Re: Indian Point Unit 3
Docket No. 50-286
NL-04-145

Subject: **Supporting Information for License Amendment Request
Regarding Indian Point 3 Stretch Power Uprate (TAC MC 3552)**

- Attachment 1: Summary Listing of RAI Responses
- Attachment 2: Additional Information for IP3 SPU License Amendment Request, Based on NRC RAIs Issued for IP2 SPU
- Attachment 3: Additional Information for IP3 SPU License Amendment Request, Based on NRC RAIs Issued for IP2 SPU (with Proprietary Information)
- Attachment 4: Additional Information for IP3 SPU License Amendment Request, Based on NRC RAIs Issued for IP2 SPU (non-Proprietary version of Attachment 3)
- Attachment 5: Errata Pages for WCAP-16212-P
- Attachment 6: Errata Pages for WCAP-16212-NP
- Enclosure A: Westinghouse Withholding Request for Attachment 3 Proprietary Information

Figure 6 — Methods for determining the allowable value

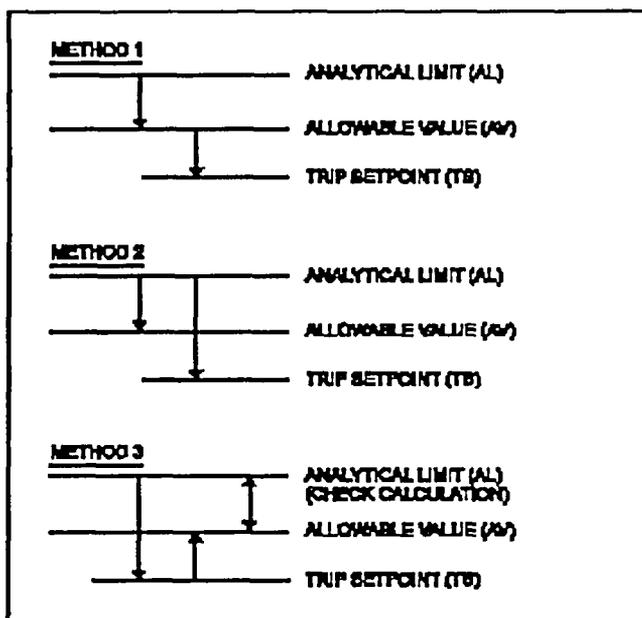
Explain how the component test procedure acceptance criteria are determined, and how the criteria provide adequate assurance that the channel AVs are suitably protected. In addition, explain how this approach meets the requirements of 10 CFR 50.36, which requires that the limiting safety system settings be specified in the Technical Specifications (TSs). Since channel performance is not assessed against the TS AVs unless some other criterion indicates that closer examination is warranted, those other criteria, which are not controlled by the TSs, can result in the TS criteria not being applied.

In method 3, the TS is determined by subtracting from the AL; margin, those uncertainties between AV and the TS (See "A" below) and those uncertainties between AV and the AL (See "B" below). Again as in method 2, $TS = AL \pm (CU + \text{margin})$. The method 3 AV is established by determining an acceptable allowance based on uncertainties between AV and the TS. This allowance is then added to the TS to establish a conservative calculated AV.

At Indian Point Unit 3, AV and the TS are determined as discussed above for Method 3. For each AL relate loop component; the Component Reference Accuracy (RA), Drift (DR) and the As-Left Tolerance (ALT) are combined using SRSS. This value for each component is the As-Found Tolerance (AFT). The AFT is the maximum value that may be used in the surveillance or calibration procedure for the component. The AFT for each AL related loop component is then combined using SRSS. This value is then added to the TS to establish the AV.

Figure NL-04-073-PVM-3-1
Probability of Correct Rejection
Sizing, Std. Dev. = 0.12, Acceptable Flaw Size 0.15

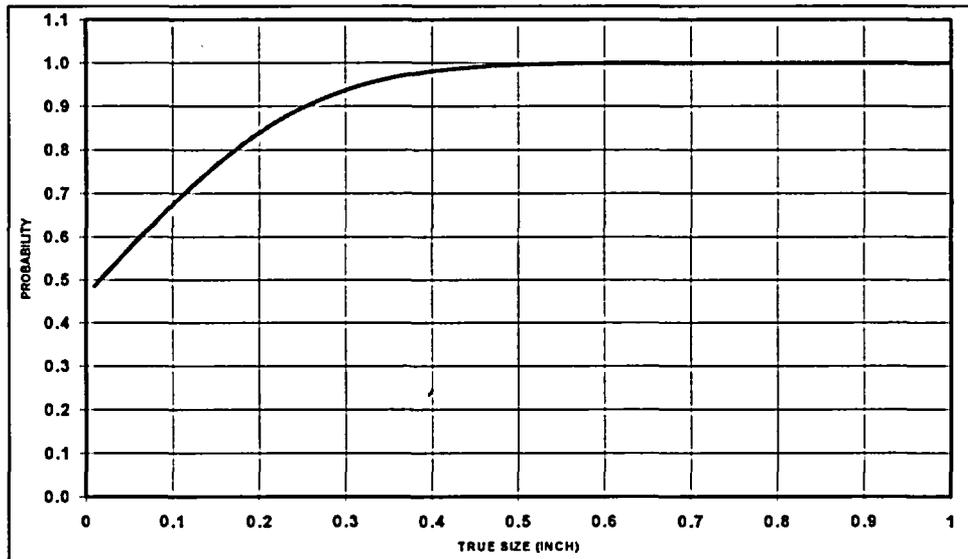
- c. Provide the data and describe the analysis that the probability of detecting a flaw with a depth of 0.5-inch is greater than 99.9%.

The probability of detection (POD) of a flaw using volumetric inspections in the reactor vessel nozzle inner radius is provided in the following reference: "Proceedings of ASME 2001 Pressure Vessels and Piping Conference, Atlanta, GA, "Technical Basis for Elimination of Reactor Vessel Nozzle Inner Radius Inspections", W. H. Bamford, et. al., July 2001". Based on Figure NL-04-073-PVM-3-1 shown below, the probability of detection for a flaw with depth equal to 0.5 inch into the base metal is approximately 99.9%.

Figure NL-04-073-PVM-3-1 depicts the expected rejection probability as a function of flaw size. Correct rejection probability considers the detection capability and the sizing capability for flaws. For example, as shown in Figure NL-04-073-PVM-3-1, the probability of detecting and rejecting a flaw 0.25 inch into the base material is equal to or greater than 90%.
